Re: **Marysville Corporate Center**
Binding Site Plan, PA22-004
Project Number 2200444.00

In response to your plan review checklist dated April 27, 2022, we have addressed the items below, with our responses following your comments.

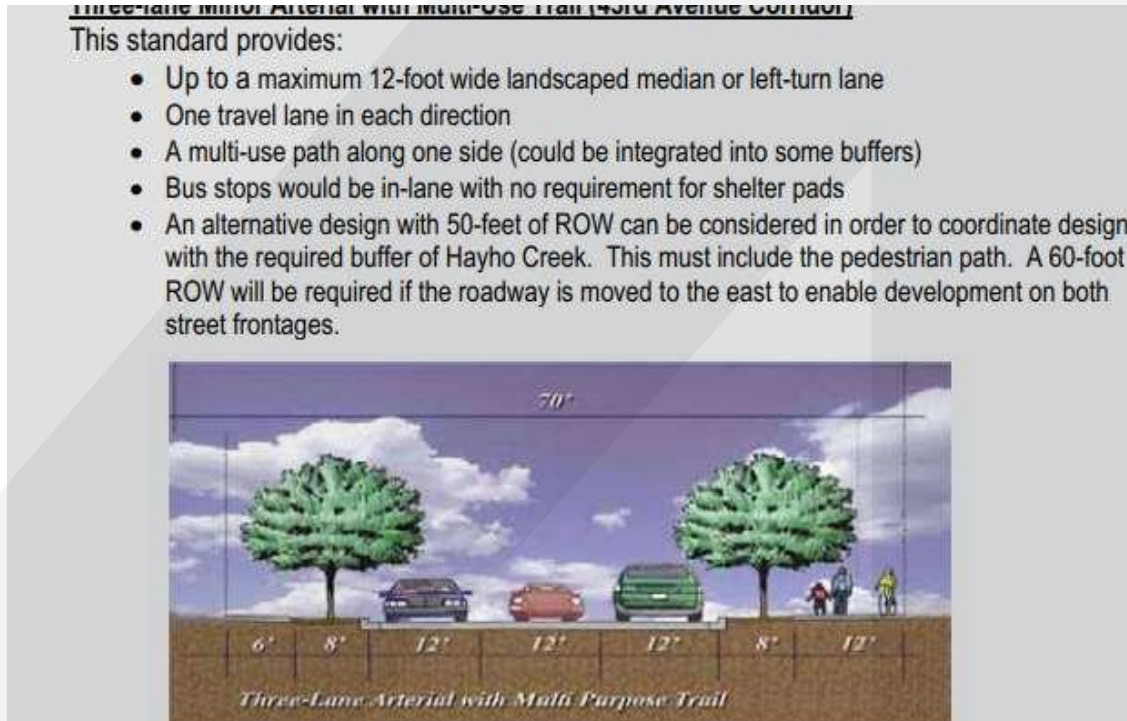
- c. *47th Ave NE is at full build out is to have 2 travel lanes, with a turn lane, curb and gutter with a planter and sidewalks. See the diagram below.*

A half street design will be allowed. The proposed alignment for future 47th Ave has changed, I'll include a diagram of the alignment in my response.

Response: Right of way dedication is shown on the preliminary BSP, no improvements of 47th Avenue are shown at this time.
